ANGLIA Range

HEATER PLENUM CHAMBER DRAIN TUBES

No 33

PASSENGER CAR SERVICE LETTER 1964 series

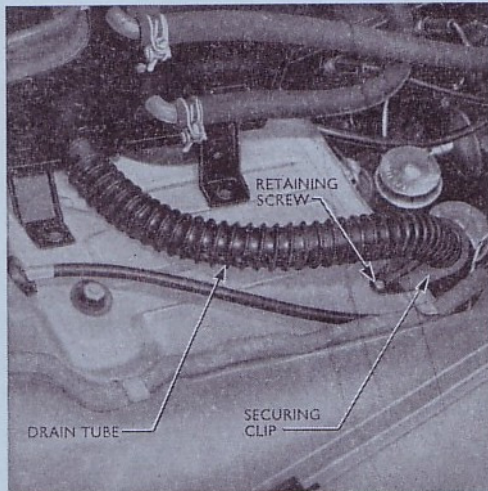
The metal plenum drain tubes and rubber elbow connections have been replaced by plastic drain tubes. The metal tubes will no longer be available in service once present stocks are exhausted.

If, for any reason, it is necessary to replace the metal tubes with the plastic ones, the holes for securing the clips to the windshield opening panel must be resited. The position of these holes is not critical but it is advisable to temporarily fit the pipe in position, refer to the accompanying illustration, and mark where the holes should be, using the clips as templates. The holes can be drilled (0.125 in. dia.), and the tubes can then be fitted and secured in position with a self-tapping screw through each clip.

Metal drain tube and integral clip ..	E542-T-1	Obsolete
Rubber elbow connection	E545-T-1	Obsolete
Plastic tube	105E-18B564	Current production
Securing clip	105E-18K272	Current production
